Reactor Oversight Process Task Force FAQ Log – January 15, 2014

FAQ Log Entering ROP Public Meeting January 15, 2014

Attachment 1 - Reactor Power vs Time

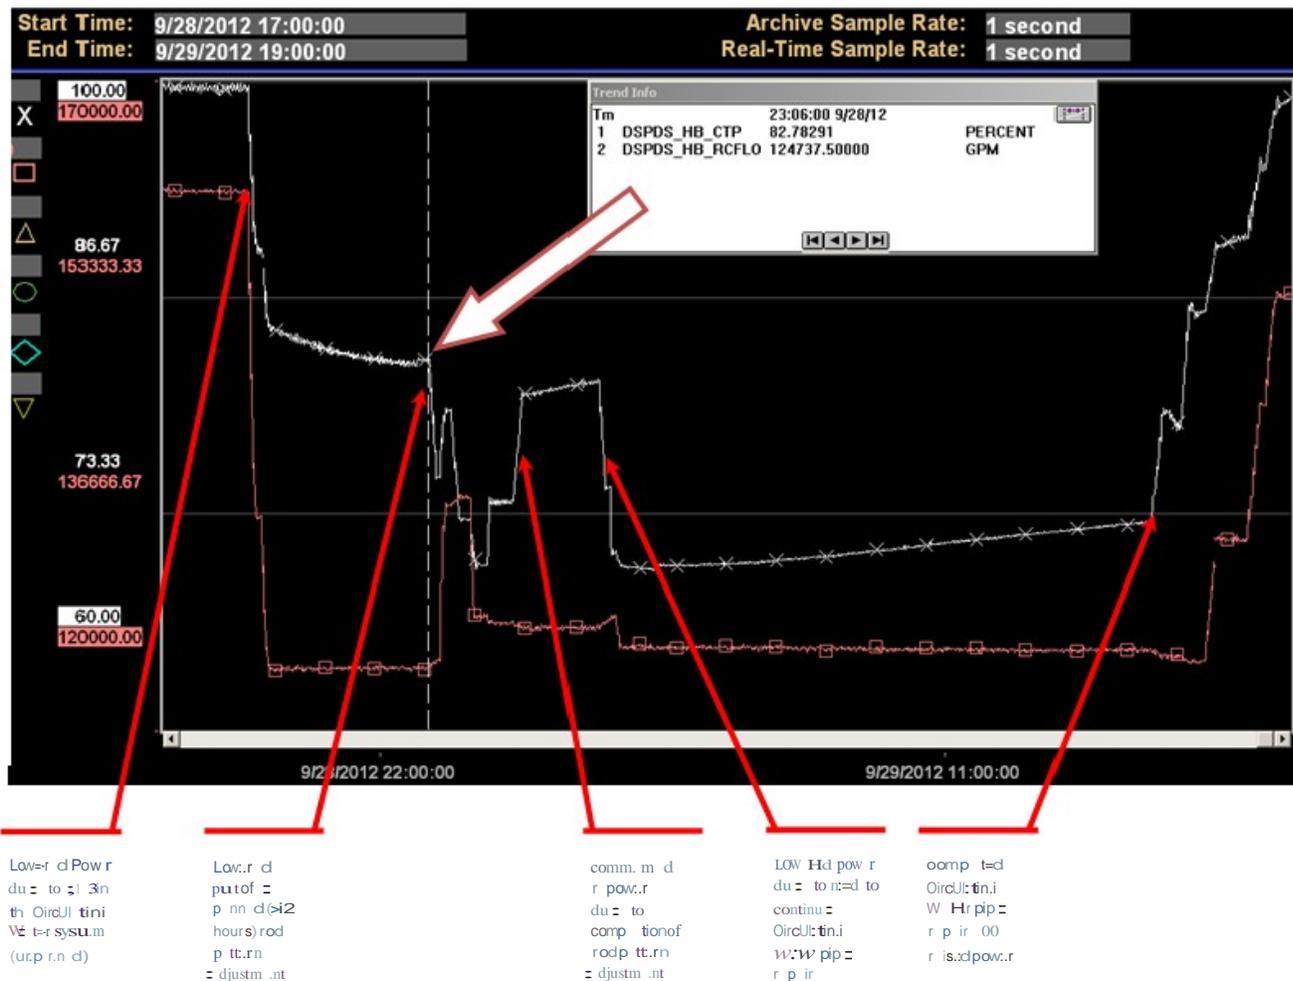
The NRC staff concludes that this event meets the first part of the definition of unplanned changes in reactor power since the downpower was initiated less than 72 hours following the discovery of a circulating water leak and resulted in a total power reduction of 30% (100% to 70%) of full power to fully resolve.

The staff concludes that the exclusion (NEI 99-02, Rev. 7, page 15, lines 15-17) does not apply to this event mainly because the circulating water piping leak was not fully resolved during the scheduled rod pattern adjustment. The circulating water repair activity continued beyond the scheduled time period for the rod pattern adjustment by several hours and therefore is not considered repaired during the rod pattern adjustment. The staff's conclusion is that this event meets the guidance in NEI 99-02, Rev. 7, as an Unplanned Power Change per 7,000 Critical Hours performance indicator occurrence.

The staff considers the guidance (NEI 99-02, Rev. 7, page 15, lines 15-17) difficult to apply because of the ambiguity of the intent (i.e., why is credit being granted when otherwise the occurrence by itself would count against the PI). The staff recommends modifying the guidance to provide a clear understanding of the basis for applying the guidance. Additionally, guidance clarity would be achieved by defining the term "planned power reduction". The staff recommends the following example in NEI 99-02, Rev. 7, page 14, lines 35-38, as a basis for the definition of a planned power reduction:
